KIRBY MORGAN

**Bulletin 2/95: Change to Product.
10 March , 1995 (Revised 9/97)**

Subject: Locking Device for Yoke

**Products Affected: Kirby Morgan
SuperLite-17A/B & U.S. Navy MK-21
Mod. O & Mod. I Helmets**

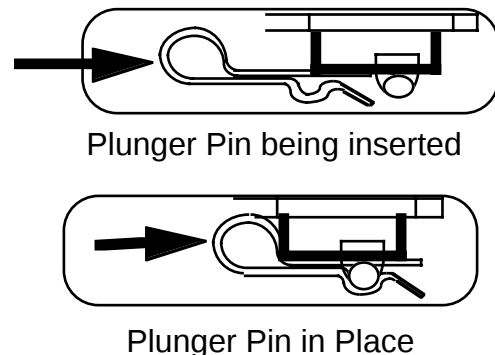
This Push Pin Latch Catch Assembly locking device is now discontinued as the standard lock shipped with each SuperLite-17A/B & U.S. Navy MK-21 Mod. O & Mod. I Helmets. No assemblies or replacement parts for this assembly are available.

DSI highly recommends that a Plunger Pin, our Part Number 540-080 be used to prevent the possibility of the yoke latching system on the SuperLite-17A/B& U.S. Navy MK-21 Mod. O & Mod. I Helmets with the original style Push Pin Latch Catch Assembly, P/N 505-015 (brass) or 505-016 (chrome) from becoming disengaged by the unintentional depression of the plunger, or due to the Neck Clamp being bent or deformed.

This Plunger Pin, part number 540-080, is not a solution to an improperly working Neck Clamp. Be sure the Neck Clamp is not damaged and is working correctly.

The Updated Standard Pull Pin Latch Catch Assembly
P/N 505-010 (brass) or 505-011 (chrome) for
SuperLite-17A/B, & U.S. Navy MK-21 Mod. O & Mod. I Yoke/Neck Clamp

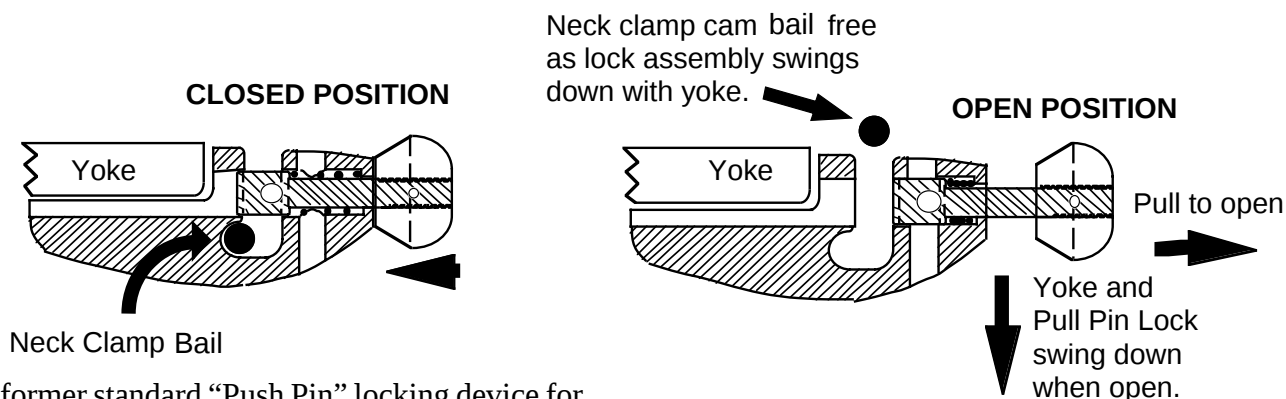
The former standard "Push Pin" locking device for the SuperLite-17A/B & U.S. Navy MK-21 Mod. O & Mod. I Helmets has now been replaced by the yoke locking device named the, "**Pull Pin Latch Catch Assembly**", Part Number 505-010 (brass) or 505-011 (chrome). All SuperLite-17A/B & U.S. Navy MK-21 Mod. O & Mod. I Helmets sold by DSI will have the Pull Pin Latch Catch Assembly on the helmet to lock the Yoke in position. The mounting system for the Pull Pin Latch Catch Assembly is identical to the former standard Push Pin Latch Catch Assembly so the older Latch Catch

Each Pull Pin Latch Catch Assembly is shipped with a **Safety Pin**, Part Number 535-900.

We recommend that the Safety Pin, P/N 535-900 be used when diving the SuperLite-17A/B & U.S. Navy MK-21 Mod. O & Mod. I Helmets with the updated standard Pull Pin Latch Catch Assembly, P/N 505-010 or 505-011, if the user requires a two step release system on the helmet. It can be used with or without a cord attached to prevent loss of the Safety Pin when not in use. All updated standard Pull Pin Latch Catch Assemblies, P/N 505-010 or 505-011, which are sold as spare or replacement parts include this Safety Pin, P/N 535-900.
